**Re: Documents from Department of Conservation related to access to the Te Kuha coal deposit**

# Te Kuha Regional Geology Map

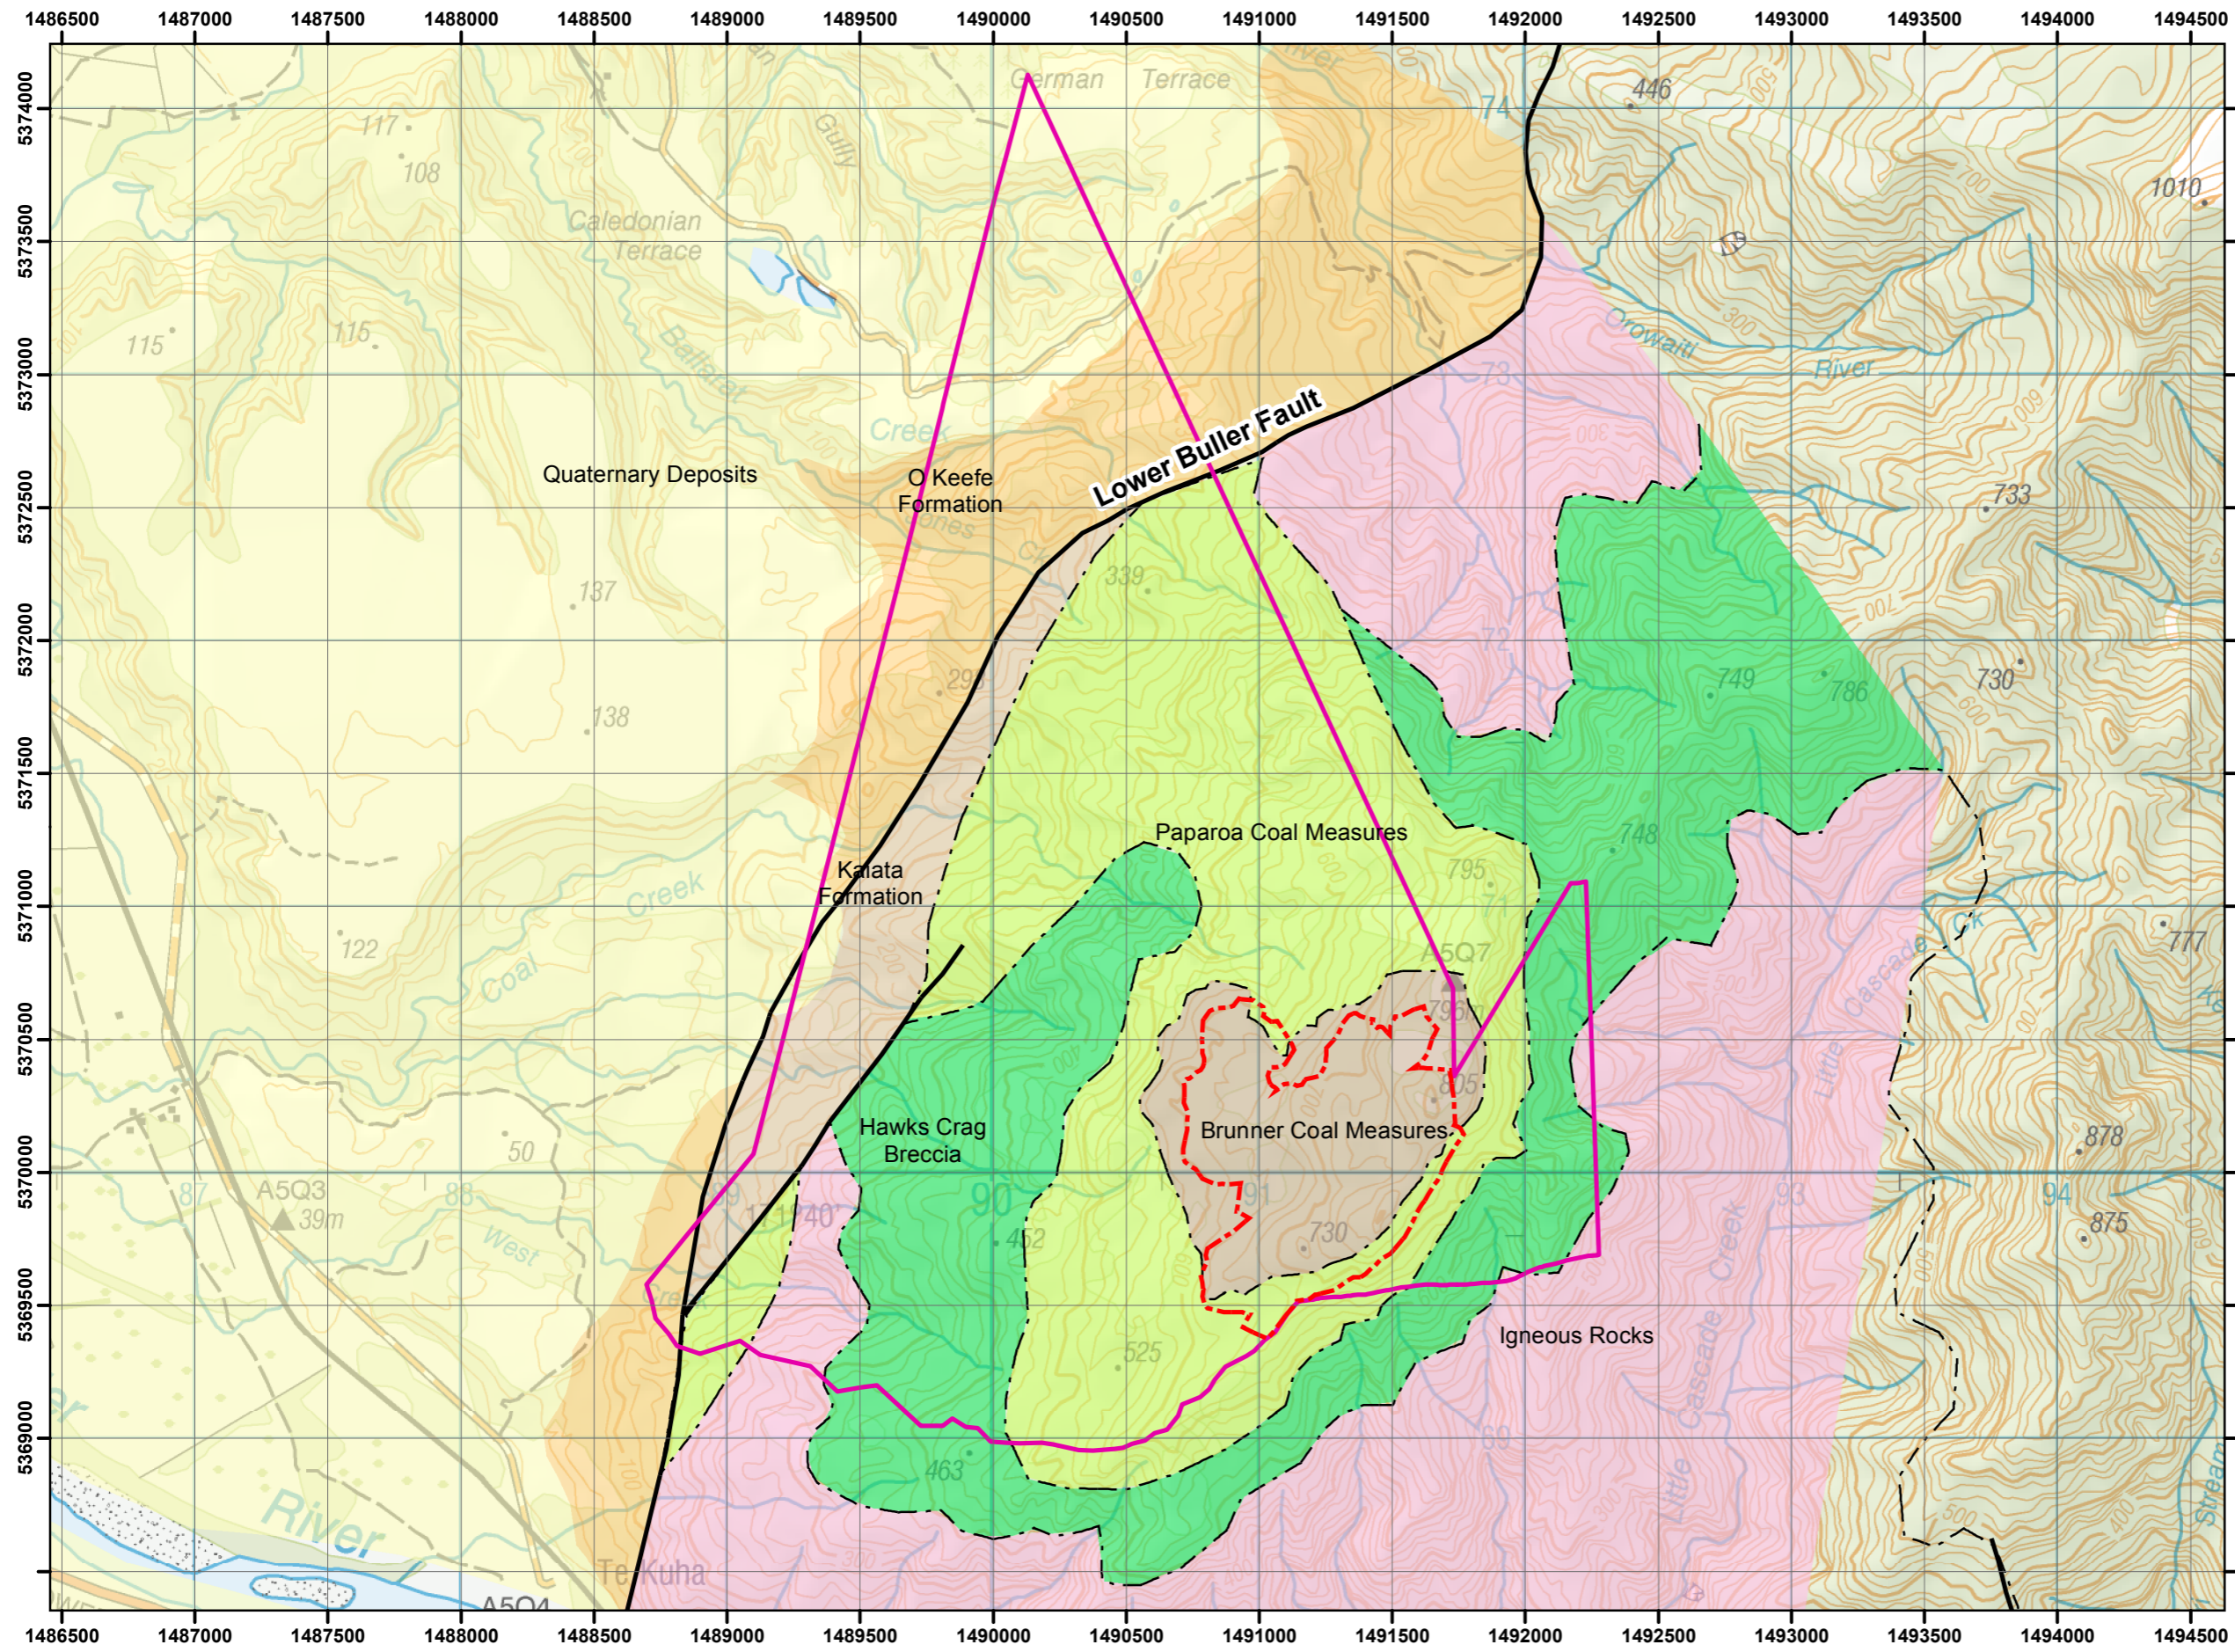
During geological investigations related to assessing the coal resources at Te Kuha, CRL Energy and collaborators identified both Brunner and Paparoa Coal Measures in this area. This is different to previous geological interpretations for the Te Kuha area that only identified Brunner Coal Measures and these new interpretations are made possible because of the drilling and analysis programme that Stevenson commissioned in 2011. This is a significant discovery because previously the Paparoa Coal Measures were not thought to occur north of the ranges inland from Punakaiki. Our revised interpretation means that the Brunner Coal Measures at Te Kuha are restricted to an area almost entirely within the proposed mine footprint, and the Paparoa Coal Measures occur in an area both within the mine and in much of the remaining permit area outside the mine footprint (Figure 1). This is our best and current interpretation, however, it could be revised further if new information becomes available from exposure of rocks along the planned access road, future drilling programmes or mine activity should operations at Te Kuha proceed.

It is likely that this updated geological interpretation has implications for the assignment of ecological areas that are related to geology such as the Brunner Coal Measures Ecological Areas. The outline for these ecological areas appear to be related to the previous geological interpretations (Nathan et al., 2002) that indicated a wider distribution of Brunner Coal Measures and are now out of date. These interpretations are referred to in Application documents supplied to Department of Conservation from Consultants engaged by Stevenson and also from reviewers of these documents engaged by Department of Conservation. The new geological interpretations by CRL Energy and collaborators have been presented to the New Zealand geological community at a national conference (Dutton et al., 2013), and will be submitted to the New Zealand Journal of Geology and Geophysics for peer review.

An extension to the previous permit boundary was granted on 2<sup>nd</sup> February 2014. This means that the current permit shape (Figure 1) should be revised in the review documents supplied by the Department of Conservation.
